Sydney Metro City & Southwest Chatswood to Sydenham section State Significant Infrastructure Application SSI 15_7400

OBJECTION BY STRATA EXECUTIVE COMMITTEE for 1-3 GORDON AVENUE CHATSWOOD

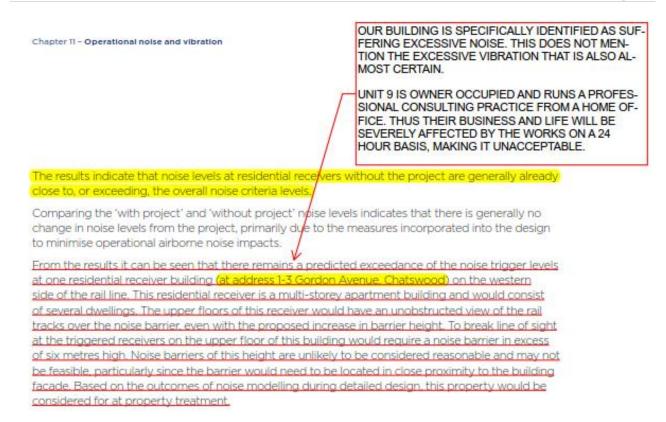
1-3 Gordon Avenue is specifically mentioned in the EIS as an address that will remain affected excessively by operational noise after completion of the work. It further states that it is impractical to create an adequate noise barrier.

The specific reference to our properties is shown below;
